Access Compliance Report Public Rights-of-Way (Curb Ramps)

Main Street: VANCOUVER_DR Cross Street: HARVEST_LN Location: NW

ADA ID: RPRK210927165654 Ramp Type: Type 6 - Directional 1 Initial Pass/Fail: Pass Overall Compliance: No Severity Score: 2

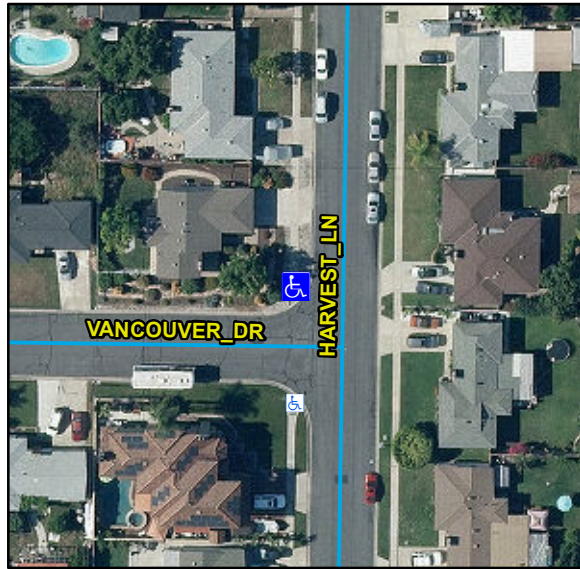
Compliance	Description	Data	Compliance	Description	Data
N/A	Ramp Length (in)	122	Yes	Flare Type LT	Curbed2
Yes	Ramp Width (in)	48			
Yes	Ramp Run Slope (%)	3.8	N/A	Flare Slope LT (%)	N/A
Yes	Ramp Cross Slope (%)	2	N/A	Flare Traversable LT	N/A
No	Grade Break	No	N/A	Flare Type RT	
N/A	Grade Break Slope (%)	N/A			Sloped
N/A	Grade Break Cross Slope (%)	N/A	N/A	Flare Slope RT (%)	2.5
	Addl Para Ramp Left?	No	N/A	Flare Traversable RT	No
	Addl Para Ramp Right?	No	Yes	DWS Provided	Yes
N/A	Landing Present	Yes	Yes	DWS Contrast	Yes
Yes	Landing Length (in)	106	Yes	DWS Length (in)	65
Yes	Landing Width (in)	48	Yes	DWS Full Width	Yes
No	Landing Run Slope (%)	2.3		DWS Offset Type	Multiple
Yes	Landing Cross Slope (%)	0.3	Yes	DWS Left Offset (in)	0
N/A	Landing Movement Obstructed?	No	Yes	DWS Right Offset (in)	0
	Landing Movement Type	N/A			
N/A	Landing Shared	No			
N/A	Marked Crosswalk 1	No	N/A	Clear Space	N/A
	Crossing 1 Direction	S	N/A	Clear Space To Crosswalk (in)	N/A

Marked Crosswalk 1 Width (in)	N/A			
N/A	Ramp Inside Crosswalk 1	N/A			
	Crossing 1 Slope (%)	11.8			
	Crossing 1 Cross Slope (%)	1.3			
Yes	Gutter Ponding	No	Yes	Curb Slope	1.9
Yes	Gutter Lip Height (in)	0		Road Run Slope (%)	N/A
Yes	Gutter Run Slope (%)	3.1		Road Cross Slope (%)	N/A
No	Gutter Cross Slope (%)	6.2		Parallel Ramp Side	Left
Yes	Overall Surface Condition	Acceptable	No	Perp Joint Present	No
	Cross Gutter Present?	No		Spandrel Present?	No
	Replace Cross Gutter?	N/A		Replace Spandrel?	N/A

Remove & Replace Entire Ramp. Remove & Replace Gutter.
